Appendix 14: Record of meeting with Selwyn District Council

Meeting Minutes: Selwyn District Plan Review - Levi Rd/Lincoln Rolleston Road
Rezoning Submission

Location: SDC Rolleston

Date: 12/10/20

PRELIMINARY ODP (1 : 5000 @A3)

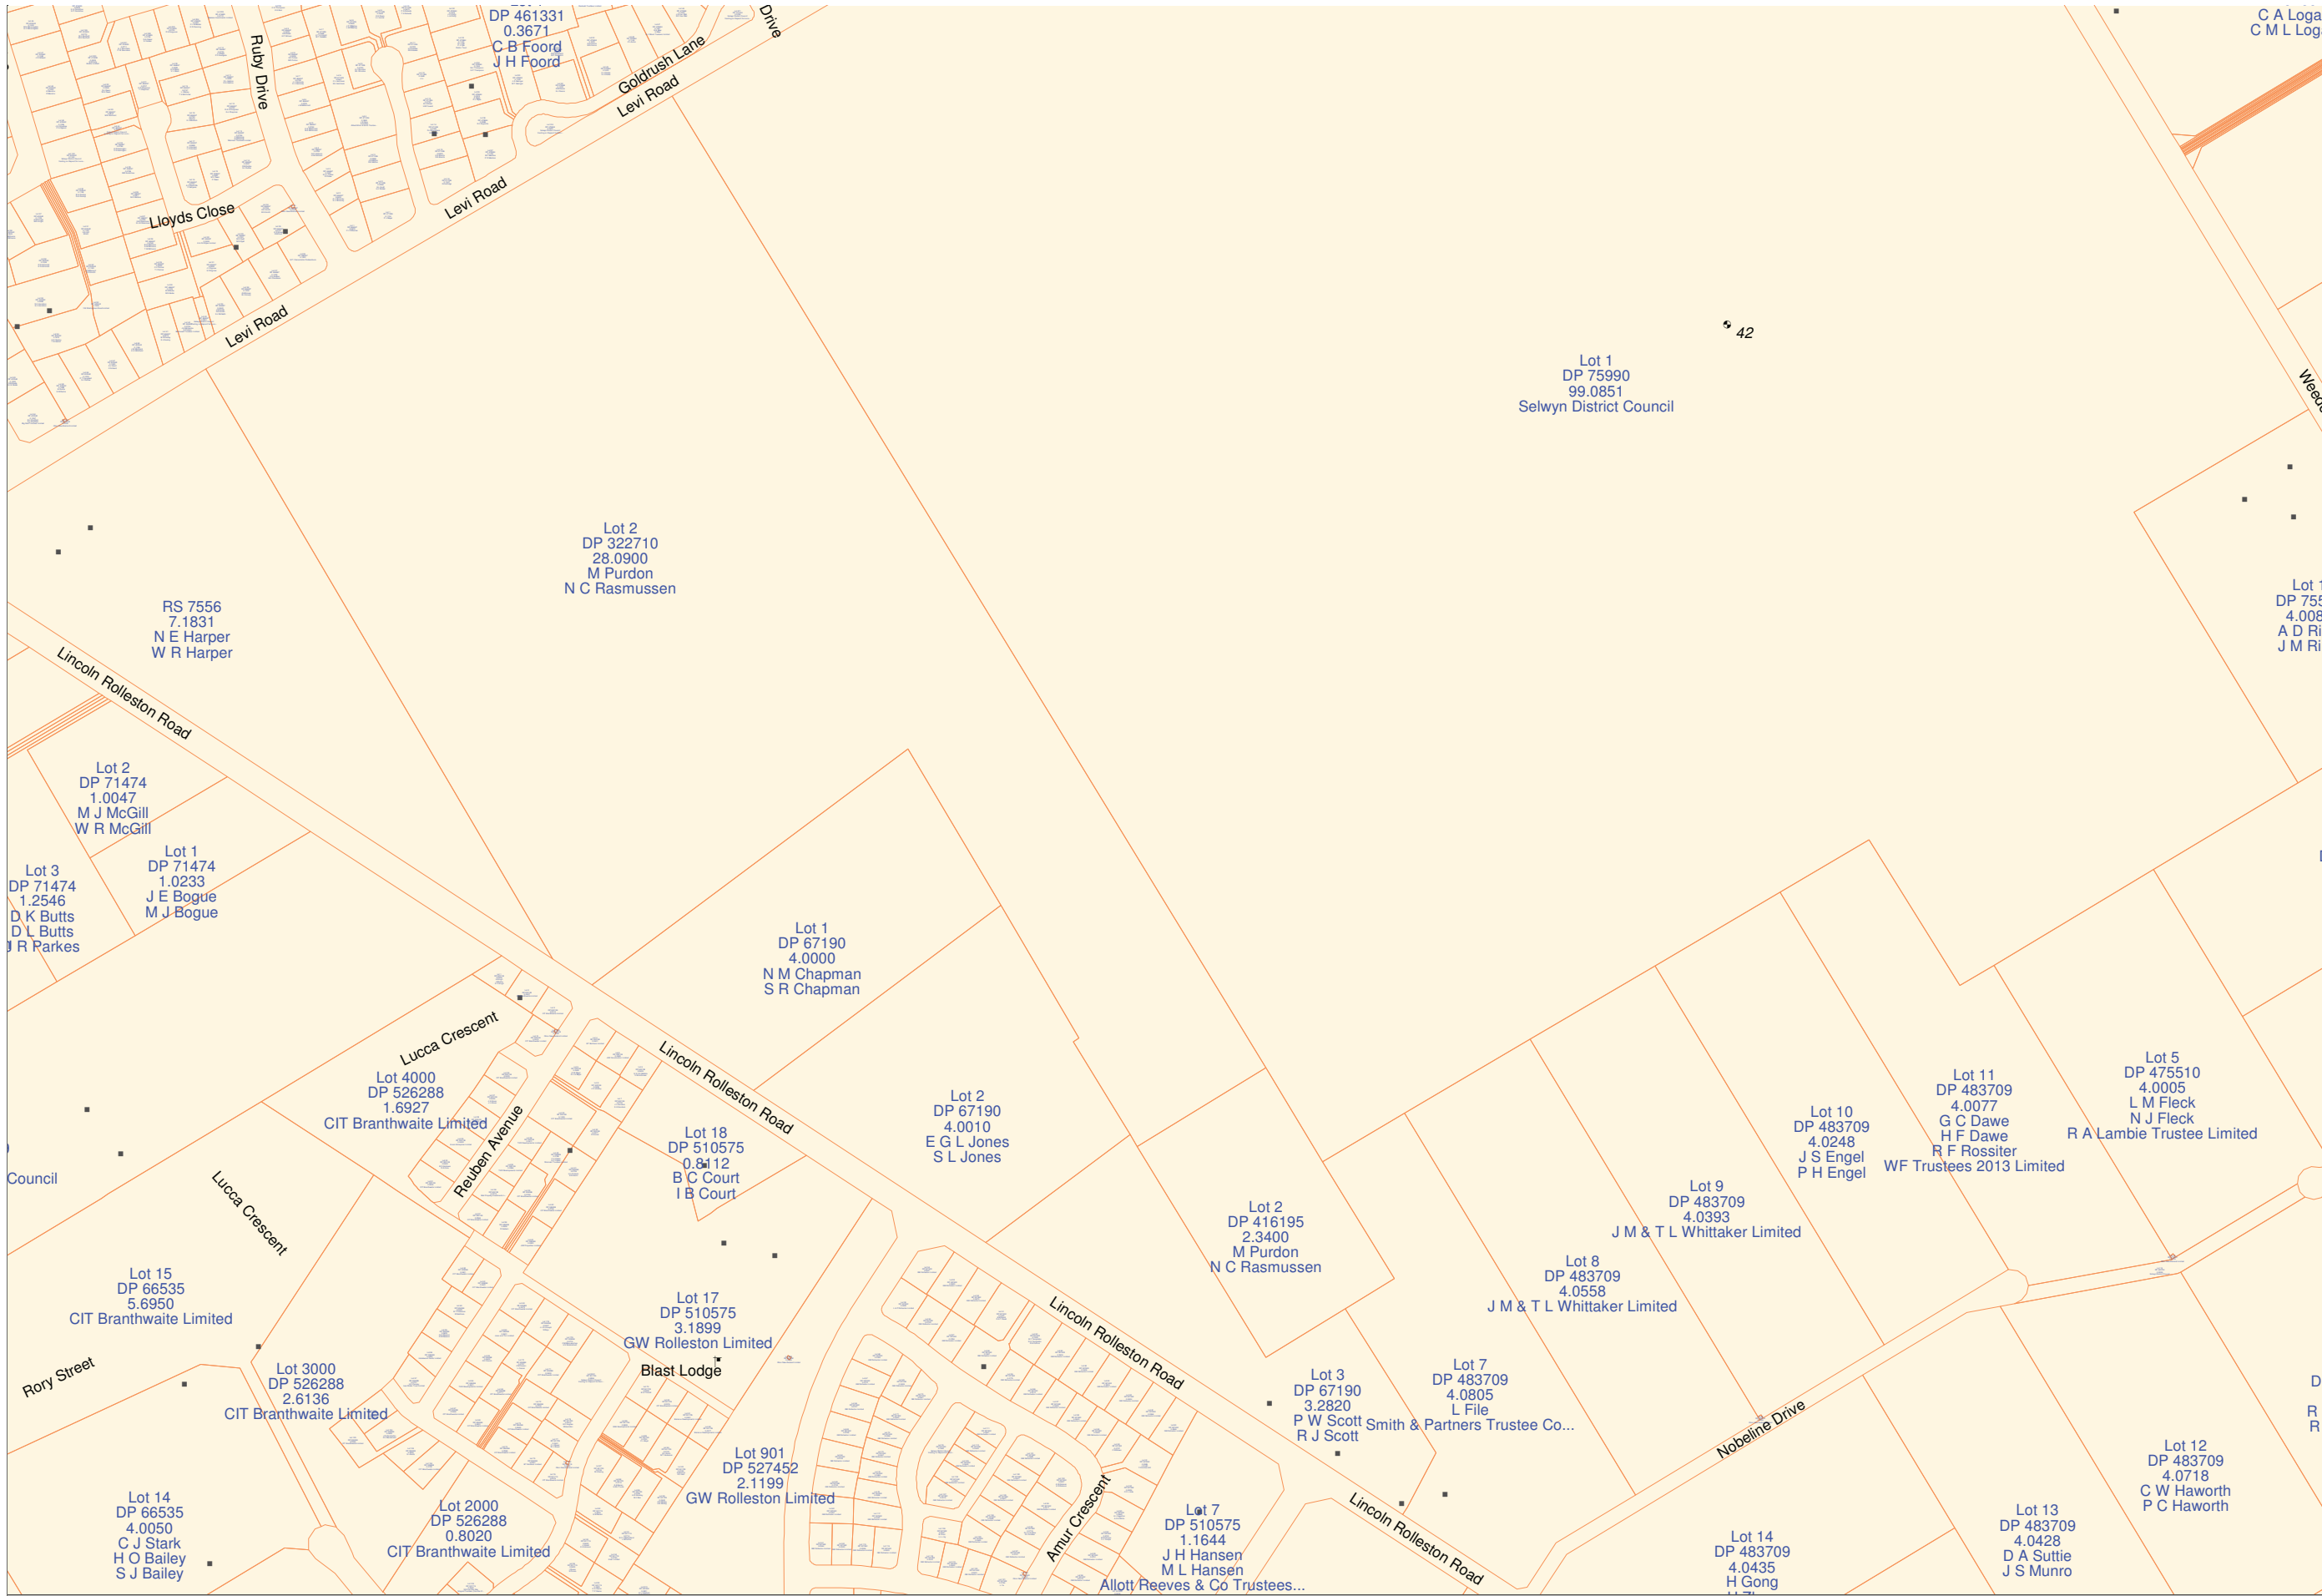
- a) No perimeter road around the Council reserve
 - b) Use of walkaways/cycleways for internal reserve circulation
 - c) ODP needs to emphasise linkages into the reserve and the form to be determined later

- e) ODP reserves are ok with good relationship to development
 - f) Connectivity to reserves good
 - g) Finalise nature of accesses later; indicative access points only on ODP

- Remove the cul de sacs facing onto Lincoln Rolleston Rd. A third vehicle access point onto Lincoln Rolleston Rd is ok.

8. DEV-RO1 (was ODP 4)
 - a) PK noted reluctance of landowners to develop
 - b) Agreed that ODP needs amending to show linkages, remove large lot Res against Levi block
 - c) Needs two connections in to Levi
 - d) Broadlands extension to be shown and can be facilitated by Public Works Act acquisition
